Humanetics Innovative Solutions, Inc.

TF-RUCC FLEX PLI TASK FORCE PRESENTATION

Comments BAsT/BGS

JANUARY 27, 2012

Long rubber verses short rubber effects on the Pendulum test

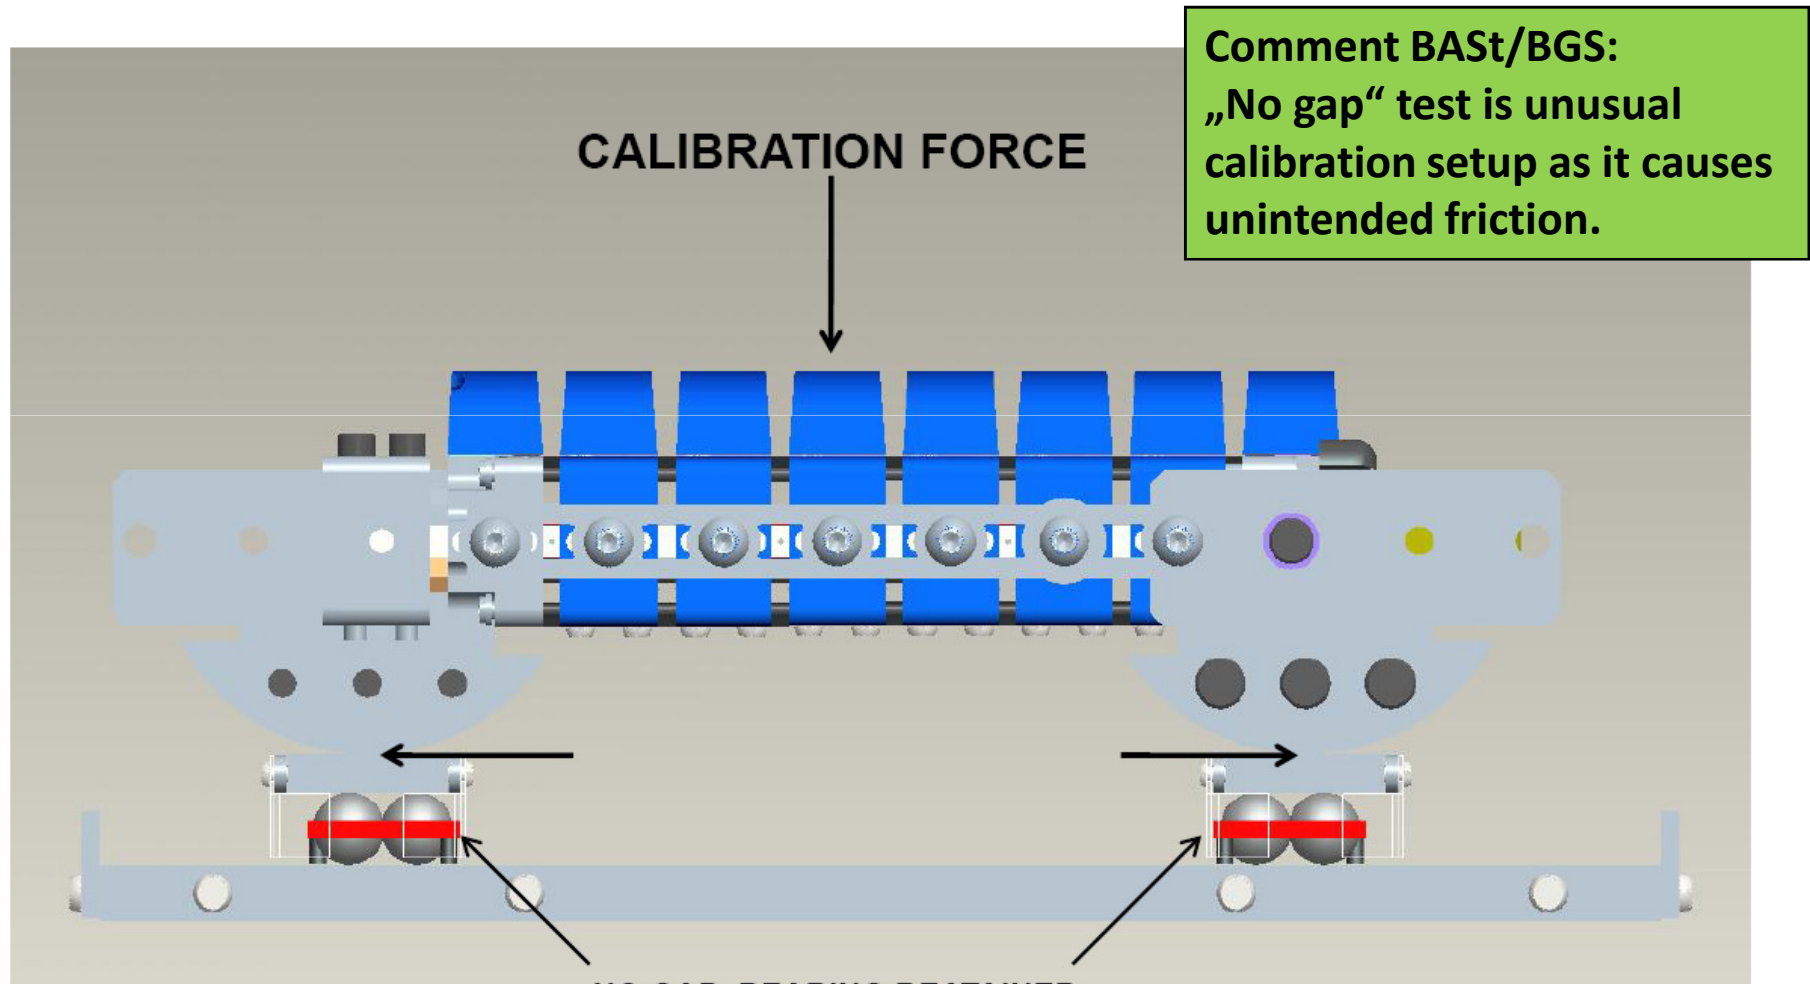
Comment BAsT/BGS:

These are the corridors !

Where are the test results ? (peak loadings and time history curves are both needed for in depth investigation)

Which impactors have been used ? Where were the tests conducted ?

How were the impactors checked during the tests ?

TEST 4: NO GAP; SHIFTS CURVE TOWARD UP IN CORRIDOR

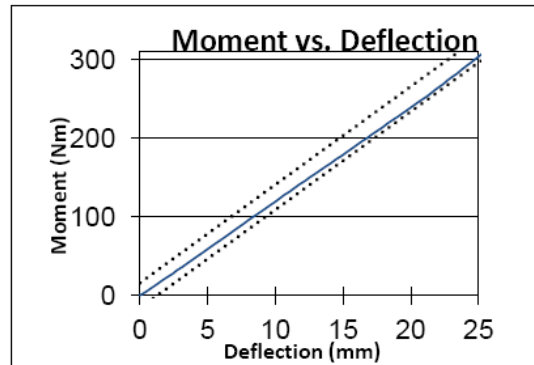
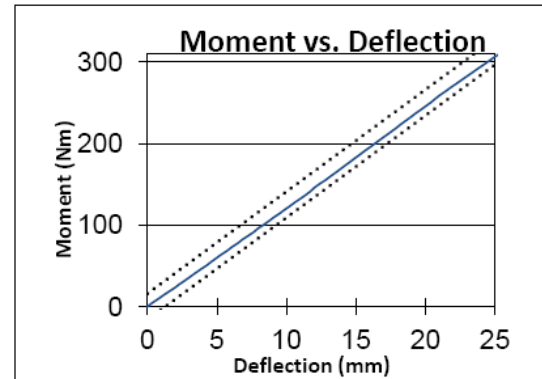
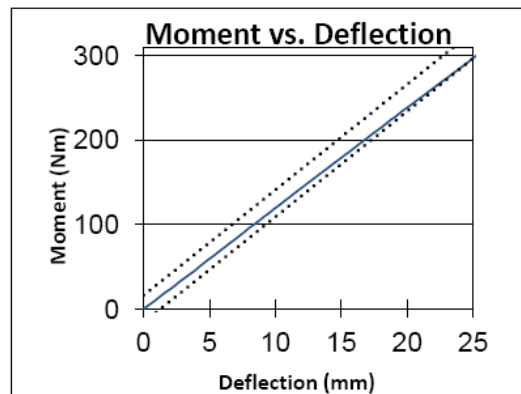
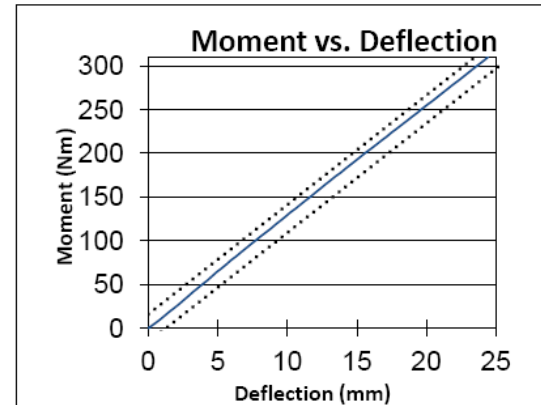
Comment BAsT/BGS:

Of course !

„No gap“ test setup causes unintended friction !
